Well Name: SHANGHAI ROOSTER 15-Well Location: T25S / R29E / SEC 15 /

Notice of Intent

Type of Submission: Notice of Intent Type of Action: APD Change

Procedure Description: **Well Name Change, Surface Hole Location Change, Bottom Hole Location Change, First and Last Take Point Changes, and Casing/Cement XTO Energy, Inc. requests permission to make the following changes to the original APD: Change Well Name from Shanghai Rooster 22-27 Fed to Shanghai Rooster 15-3 Fed Change SHL fr/375'FSL & 1160'FEL to 310' FSL & 1185' FEL, Section 15-T25S-R29E No Additional Surface Disturbance Change BHL fr/200'FSL & 990'FEL, Section 27-T25S-R29E to 200'FNL & 540'FEL, Section 3-T25S-R29E Change FTP fr/330'FSL & 990'FEL to 330'FSL & 540'FEL Change LTP fr/330'FSL & 990'FEL to 330'FNL & 540'FEL Attachments: C102 Drilling Program Directional Plan

Note: Picture below highlights BOP components that will be tested during batch operations

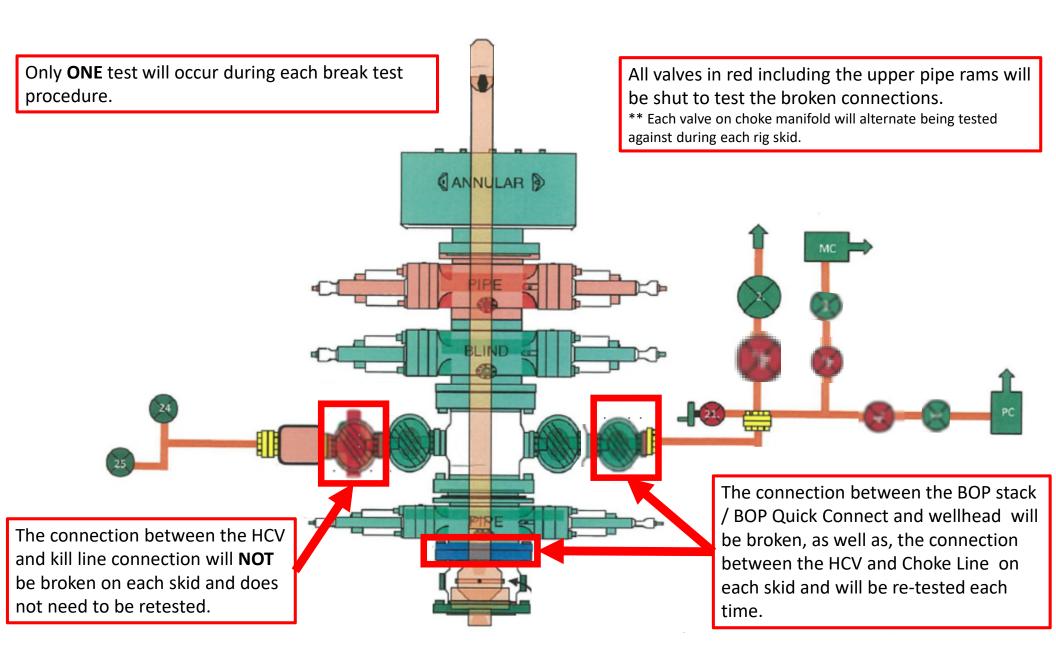
XTO Energy requests a variance to ONLY test broken pressure seals on the BOPE and function test BOP when skidding a drilling rig between multiple wells on a pad.

A variance is requested to **ONLY** test broken pressure seals on the BOP equipment when moving from wellhead to wellhead which is in compliance with API Standard 53. API Standard 53 states, that for pad drilling operation, moving from one wellhead to another within 21 days, pressure testing is required for pressure-containing and pressure-controlling connections when the integrity of a pressure seal is broken.

- 1. After a full BOP test is conducted on the first well on the pad.
- 2. The first intermediate hole section drilled on the pad will be the deepest. All of the remaining hole sections will be the same depth or shallower.
- 3. Full BOP test will be required if the intermediate hole section being drilled has a MASP over 5M.
- 4. Full BOP test will be required prior to drilling the production hole.

Wellhead diagram during skidding operations

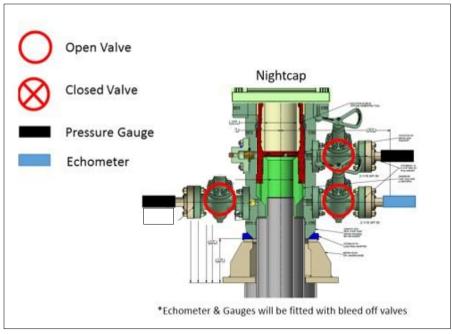
XTO requests the option to cement the surface and intermediate casing strings offline as a prudent batch drilling efficiency of acreage development.

- 6. Skid rig to next well on pad.
- 7. Confirm well is static before removing cap flange, flange will not be removed and offline cementing operations will not commence until well is under control. If well is not static, casing outlet valves will provide access to both the casing ID and annulus. Rig or third party pump truck will kill well prior to cementing or nippling up for further remediation.

Wellhead diagram during offline cementing operations

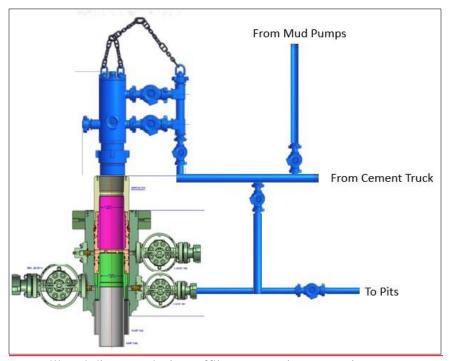
- 10. Circulate bottoms up with cement truck
 - a. If gas is present on bottoms up, well will be shut in and returns rerouted through gas buster to handle entrained gas
 - b. Max anticipated time before circulating with cement truck is 6 hrs
- 11. Perform cement job taking returns from the annulus wellhead valve
- 12. Confirm well is static and floats are holding after cement job
- 13. Remove cement equipment, offline cement tools and install night cap with pressure gauge for monitoring.
